UNITED STATES PATENT AND TRADEMARK OFFICE

APPLICATION NO.	FILING DATE	FIRST NAMED INVENTOR	ATTORNEY DOCKET NO.	CONFIRMATION NO.
10/825,907	04/15/2004	James J. Keenan	381-27-065	8929
23935	7590	05/03/2006	EXAMINER	
KOPPEL, PATRICK & HEYBL 555 ST. CHARLES DRIVE SUITE 107 THOUSAND OAKS, CA 91360			PAPE, ZACHARY	
			ART UNIT	PAPER NUMBER
			2835

Office Action Summary	Application No.		Applicant(s)	
	10/825,907		KEENAN ET AL.	
	Examiner		Art Unit	
	Zachary M. Pape		2835

DETAILED ACTION

FIG. 1

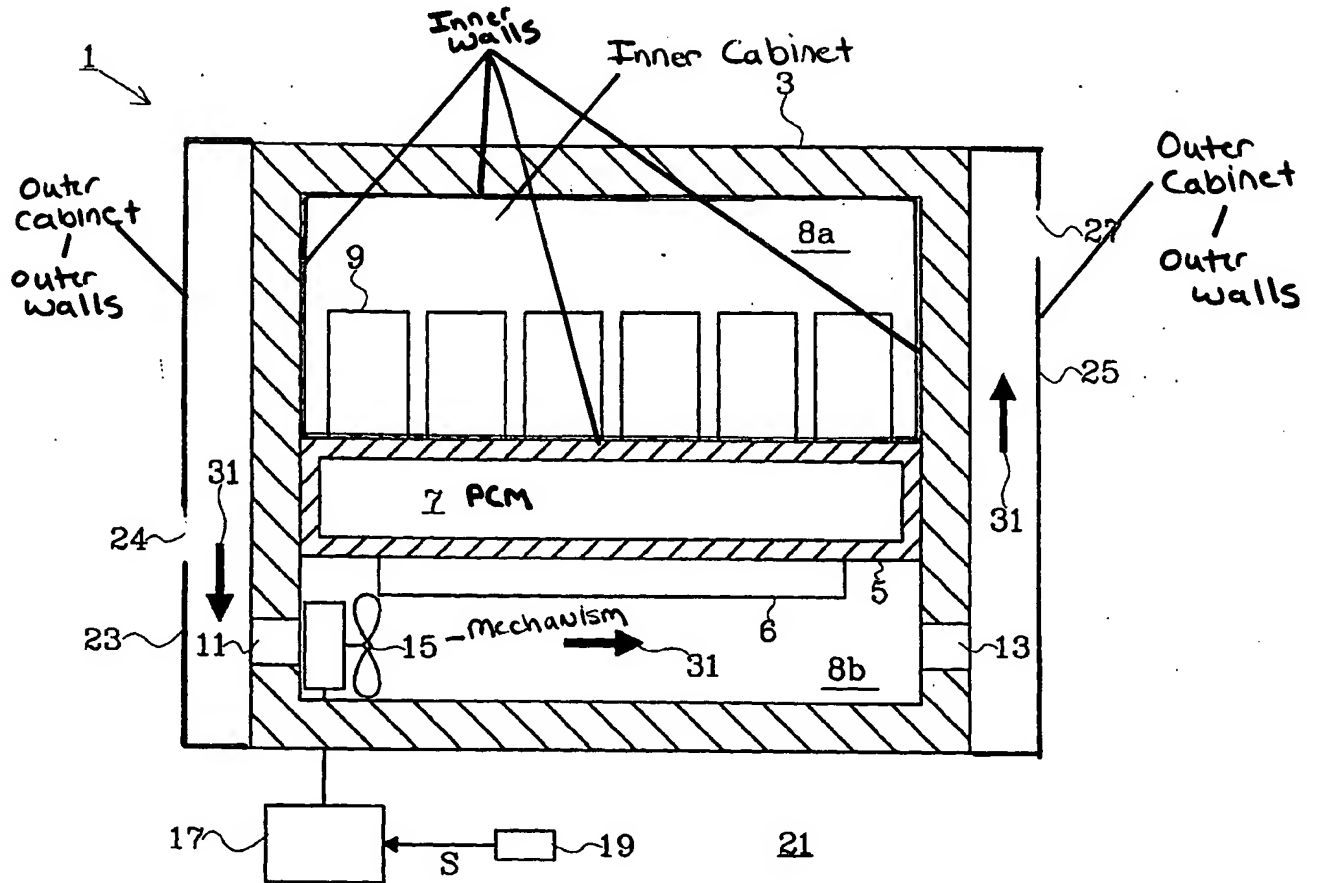
With respect to claim 1, Gudmundsson et al. teaches a cabinet, comprising: an inner cabinet (As illustrated in attached Fig) comprising a plurality of inner walls that form an enclosure (As illustrated in attached Fig); a first phase change material (PCM - 7) disposed outside said enclosure in compartments (35) and covering at least some of said plurality of inner walls (I.E. top of 5, see also Paragraph 23); an outer cabinet (Comprising 23, and 25) positioned around said inner cabinet (As illustrated in Fig 1) and also comprising a plurality of outer walls arranged such that there is a space

(Where arrow 31 is present) between said inner and outer walls; and a mechanism (15) for drawing air from outside of said outer cabinet into the space between said inner and outer walls (As illustrated in Fig 1, air enters at 24, then passes in the void between 23 and 3).

With respect to claim 2, Gudmundsson et al. further teaches that the inner cabinet comprises top and bottom walls and a plurality of substantially vertical walls running between said top and bottom wall (As illustrated in attached illustration, "inner walls").

With respect to claim 5, Gudmundsson et al. further teaches that the at least some of said outer walls (Comprising 23, 25) are adjacent to said substantially vertical walls (As illustrated in attached illustration), said mechanism (15) for drawing air arranged to draw outside air between each of said substantially vertical walls and its adjacent one of said outside walls (As illustrated in attached illustration).

With respect to claim 24, Gudmundsson et al. further teaches an electrical enclosure, comprising: a plurality of walls (As illustrated in attached illustration, labeled "inner walls") to establish an electrical component cavity (Comprising 8a); and a phase-change material (7) substantially covering at least one of said plurality of walls (Wherein one of the walls is the top wall of 5 and the phase change material 7 substantially covers the wall); wherein said phase change material insulates said electrical component cavity from heat energy (The phase change material will absorb at least

With respect to claim 30, Gudmundsson et al. further teaches an electrical enclosure, comprising: a plurality of walls (As illustrated in Fig 1) establishing an electrical component cavity (Comprising 8a); a phase-change material (7) and means (5) for containing said phase-change material, said means for containing disposed on one of said plurality of walls (5 is disposed on both the left wall (The wall in which 11 is disposed) and the right wall (The wall in which 13 is disposed)) to establish insulation against heat energy (The phase change material within the means will absorb heat energy and thus establish insulation against heat energy); wherein said phase-change material provides insulation for said electrical enclosure.

With respect to claim 34, Gudmundsson et al. further teaches an exterior wall (Wall in which the controller (17) is attached, as illustrated in Fig 1) spaced apart from at least one of said plurality of phase-change material containers (Since 5.1 of Fig 2 can be placed in 5 of Fig 1 above, the phase change material containers (35) are spaced apart from the exterior wall) to establish an air space (8b).

With respect to claim 39, Gudmundsson et al. further teaches an electrical enclosure, comprising: a phase-change panel (5); an exterior panel (The bottom most panel in which 17 is attached as illustrated in Fig 1) spaced adjacent to said phase change panel; and a fan (15) to circulate air between said phase change panel and exterior panel; wherein said fan reduces thermal energy introduced to said phase-change panel by said exterior wall (Since the fan will carry away heat the exterior panel, it will reduce thermal energy introduced to the phase change panel by the exterior wall).

With respect to the applicants' remarks to claims 24-29 that, "the phase change material would have to be on the inside of any cavities taught by Gudmundsson", the examiner respectfully disagrees. As detailed in the attached illustration, the examiner has defined the cavity to be the space (8a) which is surrounded by the inner walls (Of which the top wall of 5 which the batteries appear to rest on are included). Since the PCM is located below the top wall of 5, it is disposed outside of the component cavity.

FIG. 2

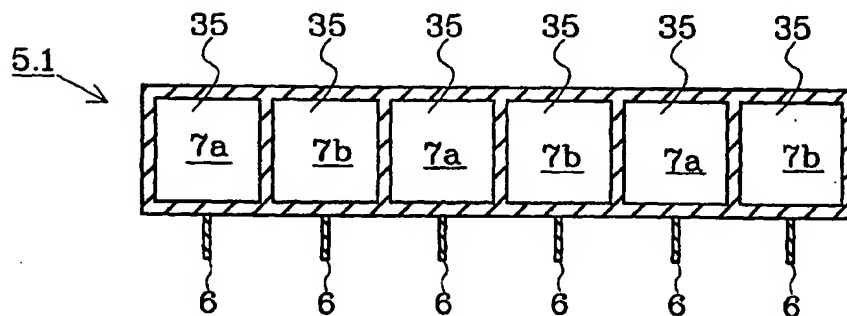
With respect to claim 41, Gudmundsson et al. further teaches that the phase-change panel comprises: spacers (Fig 2 illustrates spacers dividing each cavity (35)) to maintain a cavity for a phase-change material disposed in said phase-change panel.
